CBD AND SOUTH EAST LIGHT RAIL PROJECT

STATE SIGNIFICANT INFRASTRUCTURE APPROVAL (SSI-6042)

MODIFICATIONS REPORT

DECEMBER 2014

Figure 3.3 Proposed modification to the Grosvenor Street stop

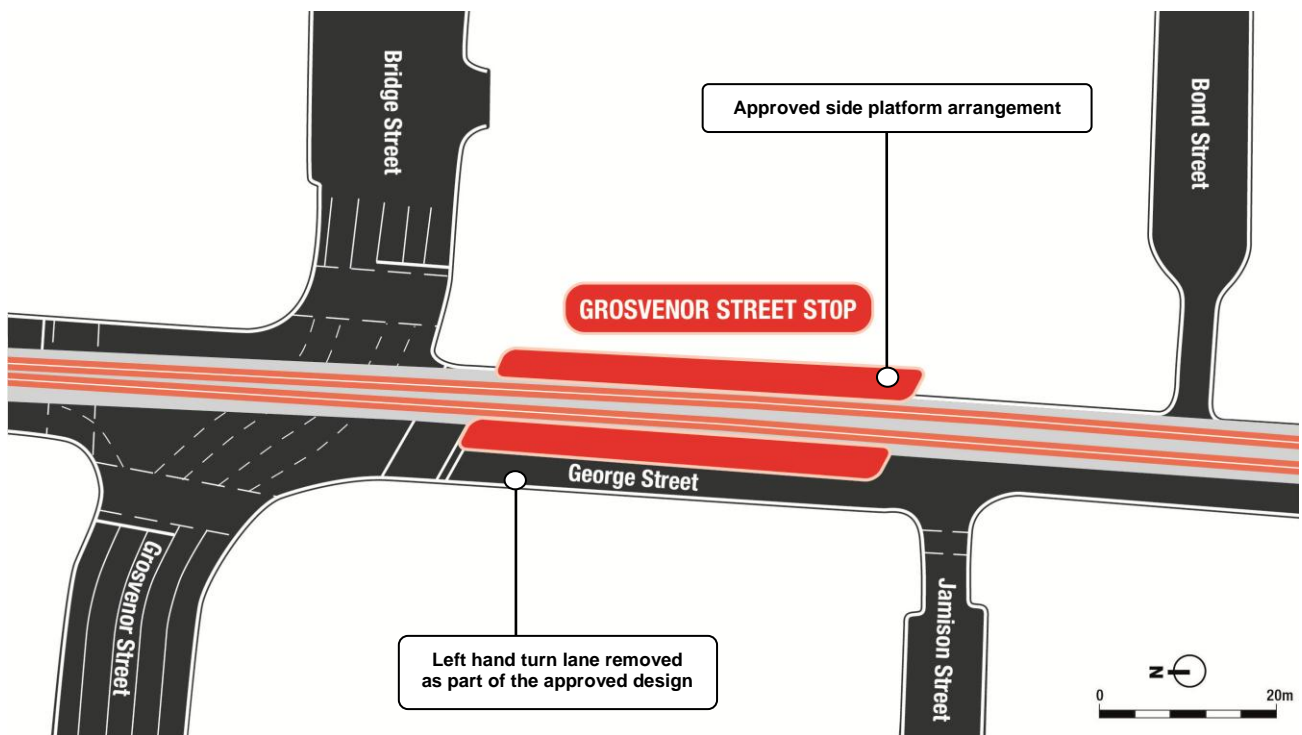
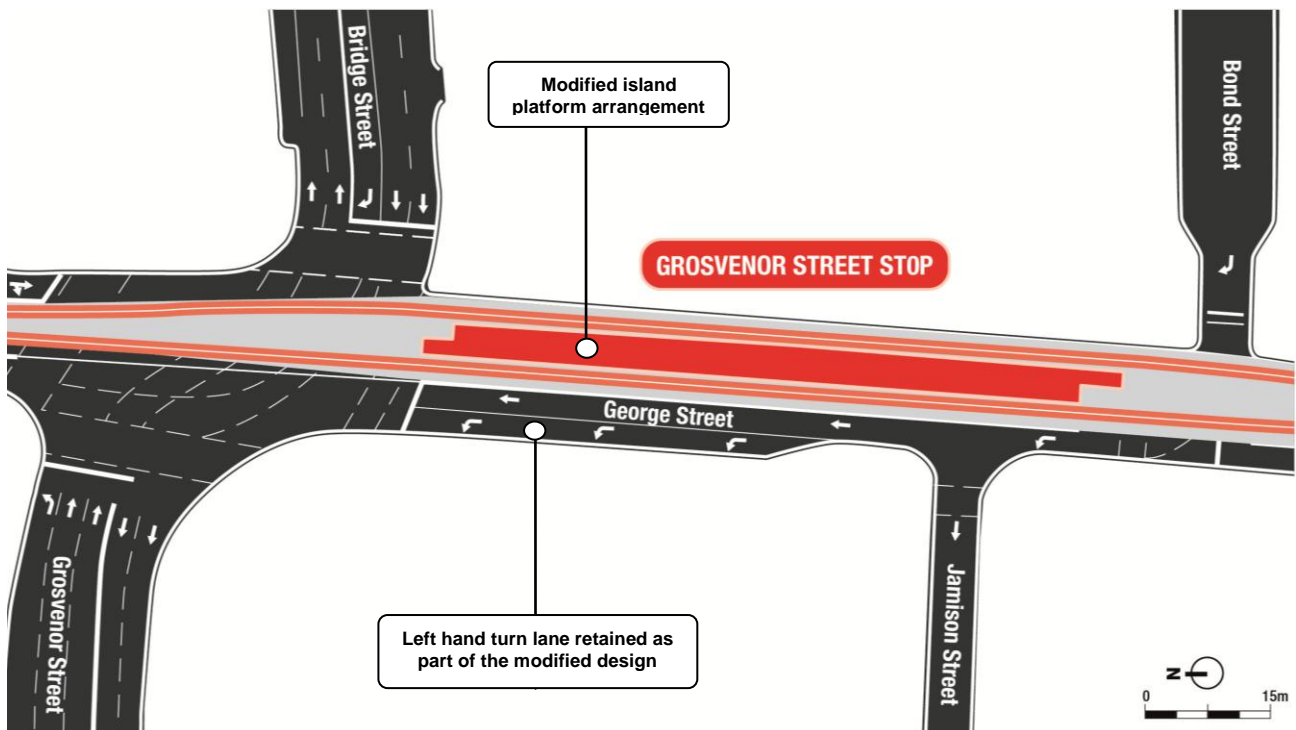
The refinement of the Grosvenor Street stop design would change the approved stop from two side platforms to an island platform. The island platform would continue to be located in the same location along George Street, between the Grosvenor Street/Bridge Street intersection to the north and Jamison Street to the south. The modified design would allow for the retention of an additional, northbound traffic lane, specifically the retention of the existing dedicated left hand turning lane from George Street into Grosvenor Street (refer to Figure 3.3). Similarly to the approved project, no southbound traffic lanes would be provided along this section of George Street.

Modified pedestrian crossings at each end of the platform would continue to provide access to the east and west sides of George Street.

Figure 3.4 Plan of the modified Moore Park stop arrangement

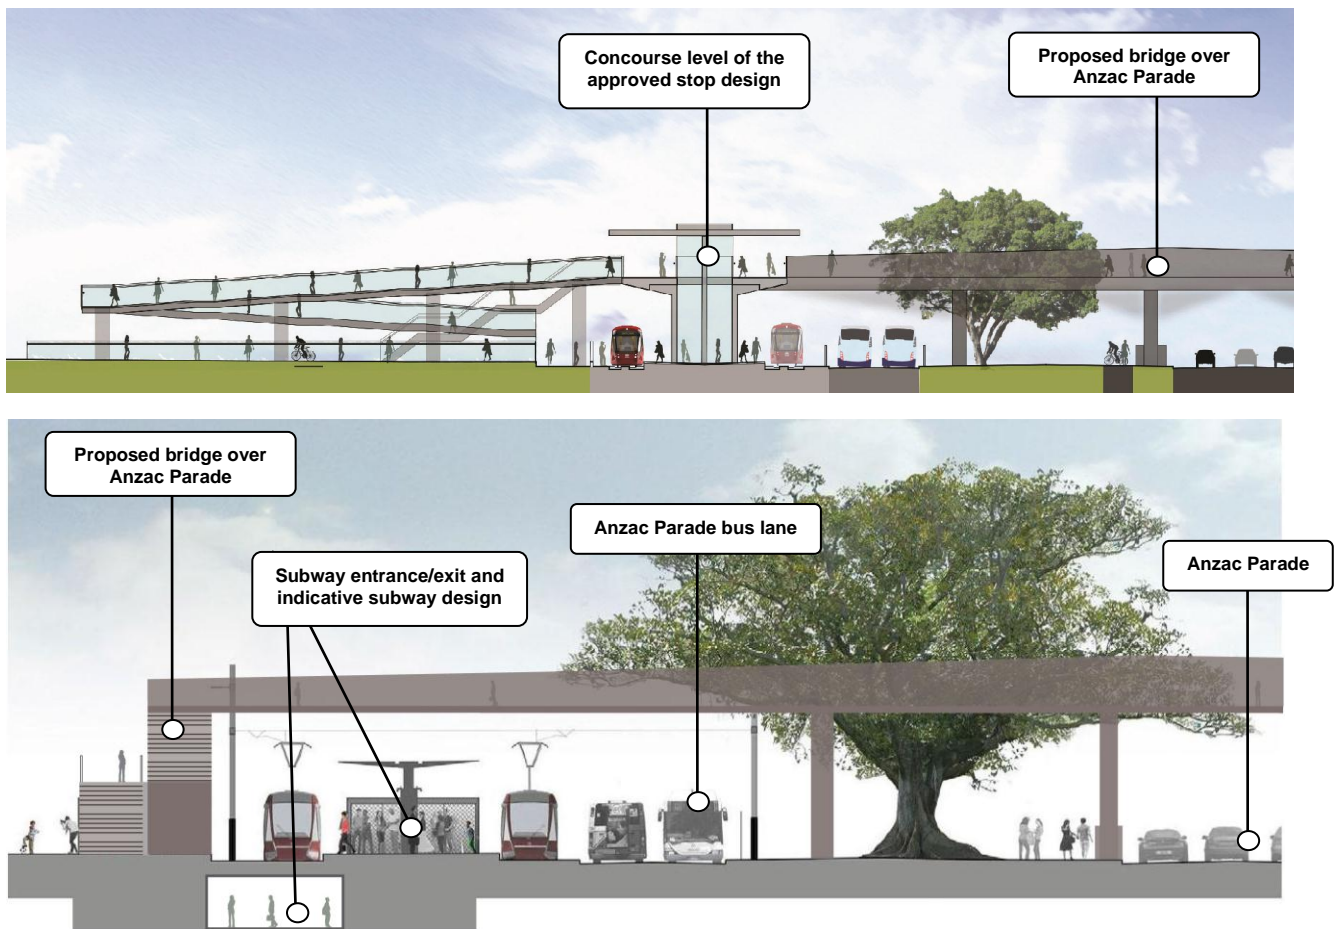
Similar to the approved project, the modified Moore Park stop would consist of an approximately eight metre wide island platform, which is accessed from both ends (refer to Figure 3.4).

Access would be controlled through the use of guard railings and gates, which would be staffed during event times. During events, passengers would be directed to the centre of the stop to enable an even distribution between the two subways minimising congestion. The design has been developed to safely manage crowds by introducing subway entrances/exits at each end of the Moore Park stop platforms. An indicative layout of the modified Moore Park stop design is provided in Figure 3.4.

Due to the proposed removal of the elevated concourse from the Moore Park stop, the modified design would require the access to the approved pedestrian bridge over Anzac Parade to be modified to incorporate new ramps and stairs at the eastern end of the pedestrian bridge. The separated public access to the pedestrian bridge over Anzac Parade would continue to enable safe crossing for pedestrians and school children from the Sydney Boys and Girls High Schools, and for the general public. The location of the proposed stairs/ramps providing access to the pedestrian bridge is shown on Figure 3.4).

Figure 3.5 Indicative elevation of the approved project (top, looking south) and indicative elevation of the modified Moore Park stop arrangement (bottom, looking south)

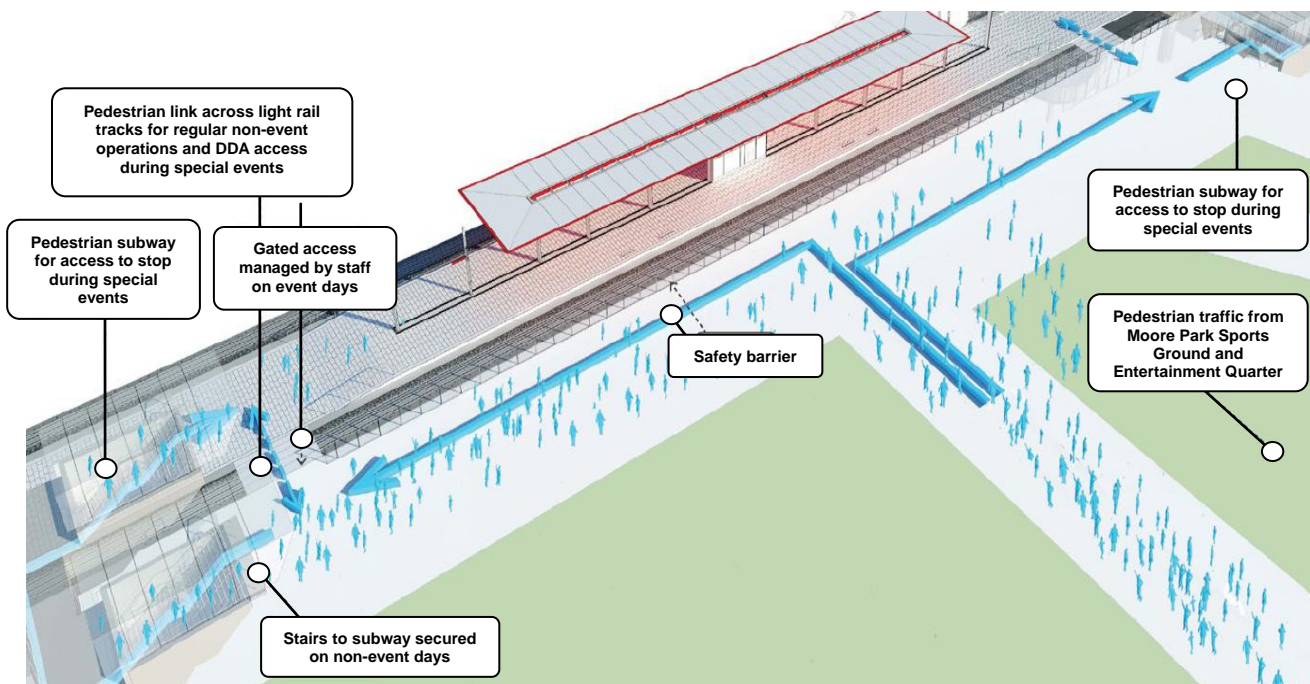
The stop would be specially managed and staffed on event days when passenger capacity is significantly increased. To ensure continuous on-time operation of the light rail network, the Moore Park stop is proposed to include subway access for passengers during special events. The modified design would avoid the need for an elevated concourse level and minimises level change for passengers ensuring safe and timely operations (refer to Figure 3.5).

Figure 3.7 Indicative arrangement for the George Street/Ultimo Road intersection

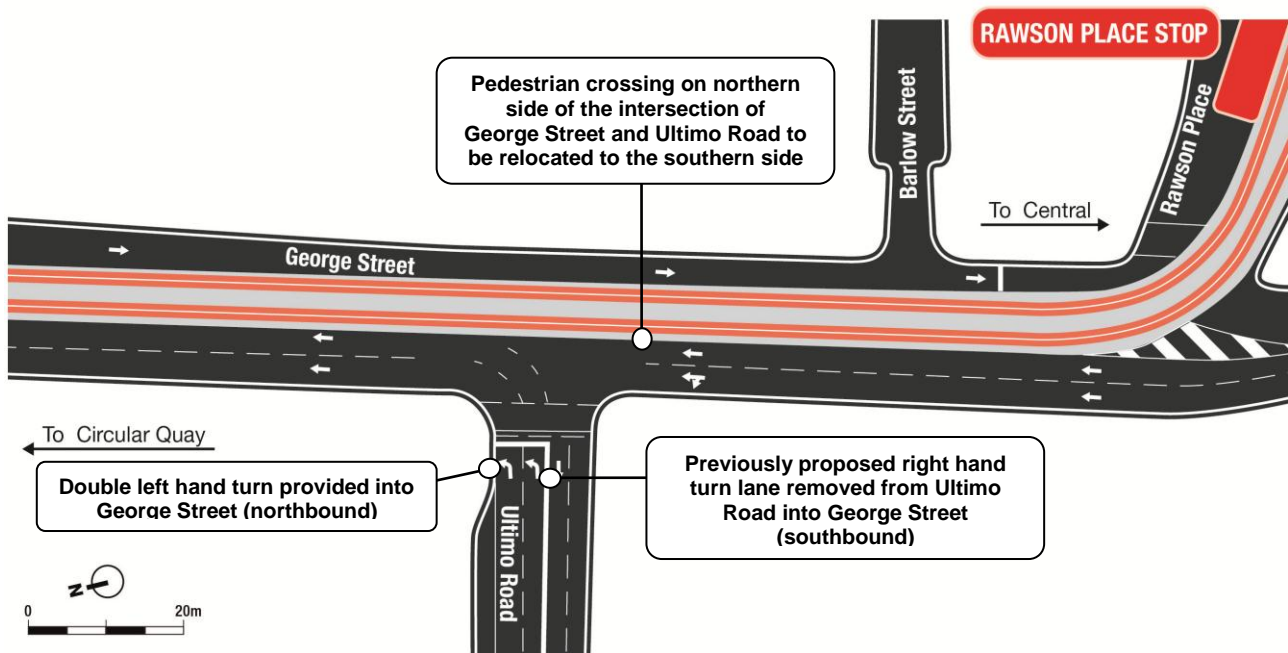
The George Street/Ultimo Road intersection would be reconfigured to provide left-in/left-out traffic operation, with the removal of the right turn movement from Ultimo Road into George Street (refer to Figure 3.7). The pedestrian crossing of George Street would be relocated to the southern side of the intersection of George Street and Ultimo Road. These changes would be required due to insufficient available storage length between Hay Street and Ultimo Road for the larger LRVs.

A double left-turn would be provided in Ultimo Road which would improve the stop line capacity for eastbound traffic (refer to Figure 3.7). As the kerbside lane on George Street turns left at Hay Street (north of Ultimo Road), assessment of this change has identified that some merging/weaving activity would occur in George Street between Ultimo Road and Hay Street. However, given the low speed CBD road environment, and noting a reasonable demand for the left-turn at Hay Street, no significant operational or safety issues are predicted as part of the proposed modification.

Figure 3.8 Indicative arrangement for the Devonshire Street/Little Riley Street intersection

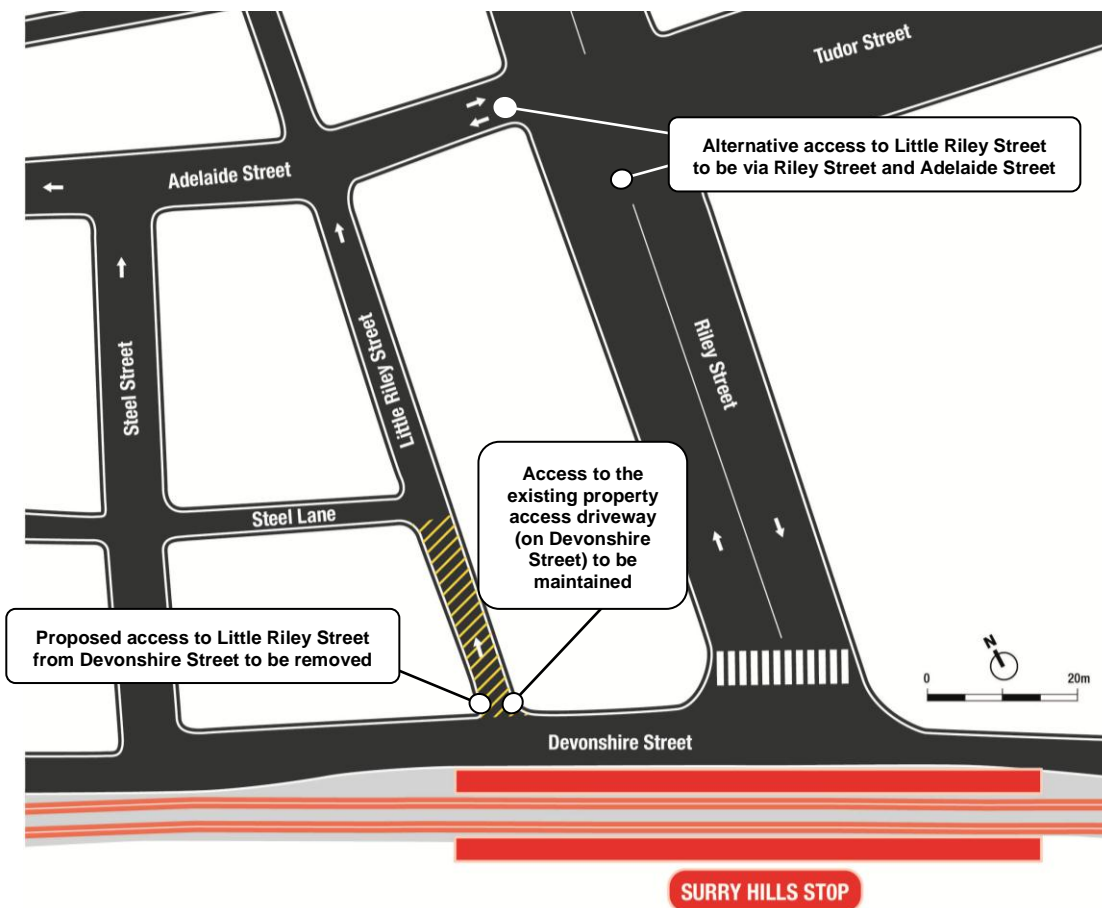
The increased length of the proposed light rail stop platform at the Surry Hills stop would result in the access to Little Riley Street from Devonshire Street becoming restricted and turning movements into Little Riley Street would potentially disrupt vehicular traffic heading eastbound along Devonshire Street. As a result, it is proposed that the existing access from Devonshire Street into Little Riley Street be removed (refer to Figure 3.8).

Figure 3.19 Revised Alison Road alignment and relocated Royal Randwick Racecourse stop

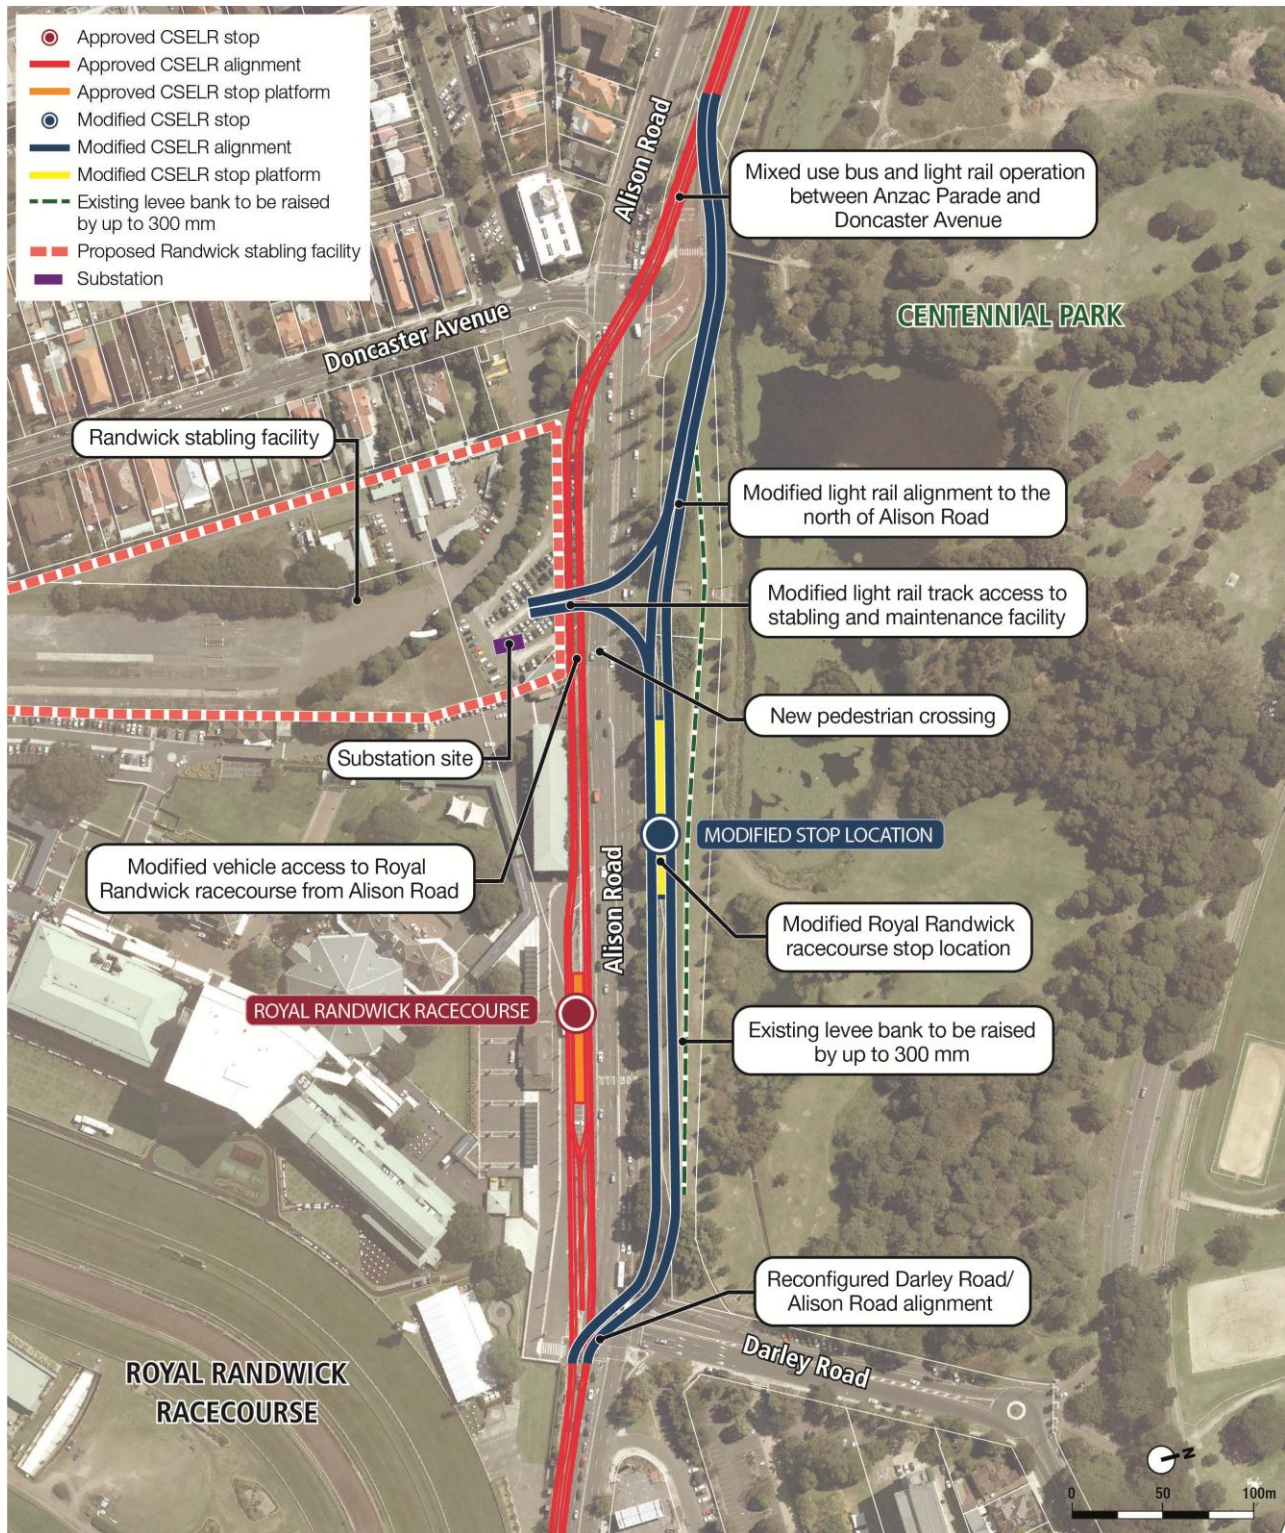
Figure 3.19 provides an overview of the modified design of the light rail alignment and Royal Randwick Racecourse stop location.

As described above, the Royal Randwick Racecourse stop would be relocated to the northern side of Alison Road and would allow for the retention of the existing bus facilities at the racecourse during light rail construction and operation. The layout of the relocated stop would be similar to the approved project, providing a wide, single island platform which would cater for large numbers of passengers during special events at the racecourse (refer to Figure 3.19).

Figure 3.20 Proposed arrangement of the Alison Road/Darley Road intersection

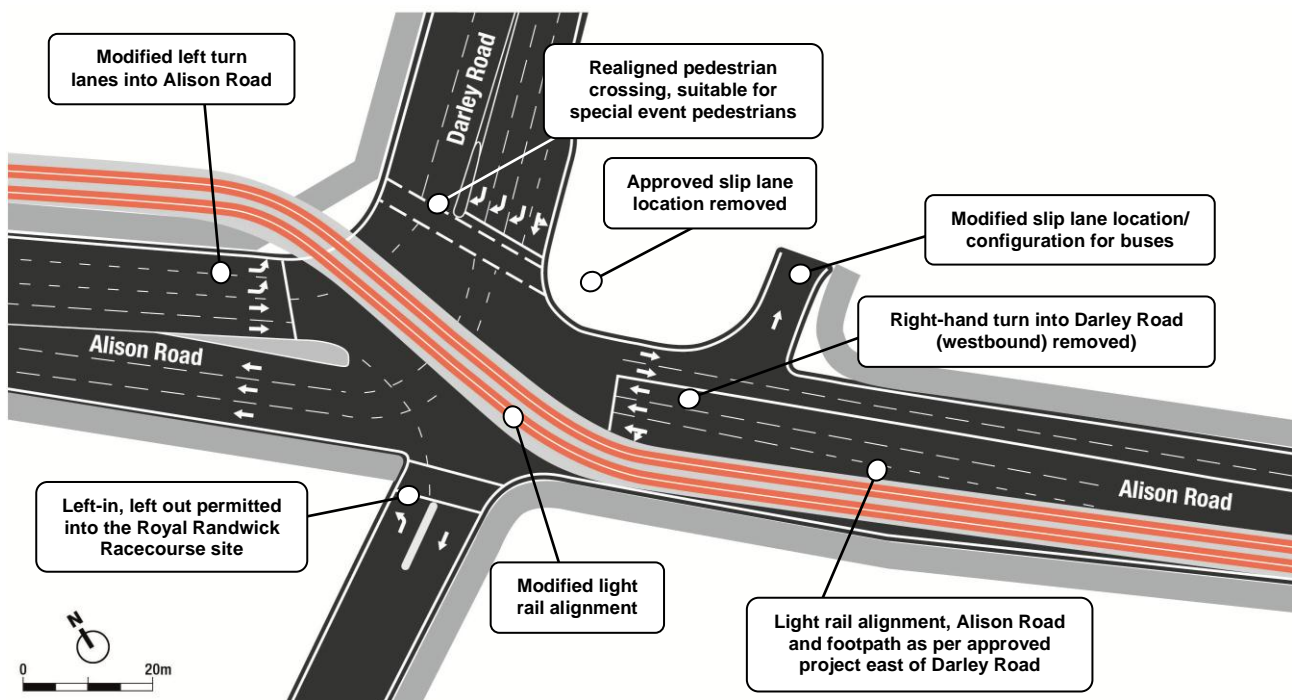
At the intersection of Alison Road and Darley Road, the modified alignment would cross through the intersection and continue to the east along the approved alignment as described in the CSELR Project Submissions Report (Transport for NSW, 2014), consisting of a side running alignment along the southern side of Alison Road and Wansey Road. This alignment would retain two eastbound and three westbound traffic lanes. Figure 3.20 shows the modified intersection design.

Figure 3.21 Elevation of the proposed increase to the height of the existing levee including proposed light rail alignment and pathways

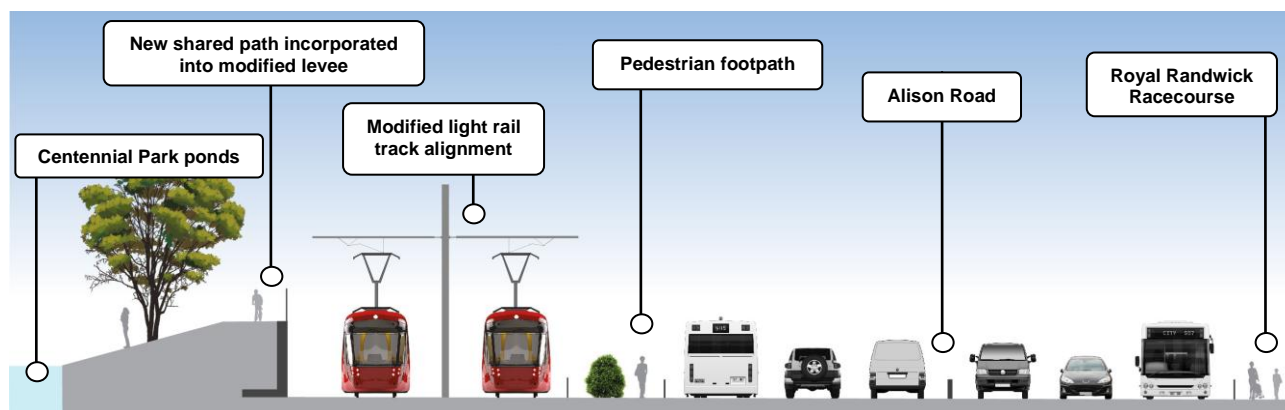
To allow for the new alignment to be located at the same level as Alison Road whilst maintaining the existing levee, a new retaining wall, approximately 200 metres long and up to approximately three metres in height would be required along the central portion of the modified alignment (refer to Figure 3.21).

The existing turf covered levee would be re-graded with a new path along the northern side of the alignment, with an approximately three metre high retaining wall used adjacent to the realigned light rail lane. Native grasses/shrubs would be planted on the re-graded embankments. The species of grasses/shrubs would be determined following consultation with Centennial Park. A typical elevation of the proposed levee arrangement is shown in Figure 3.21.
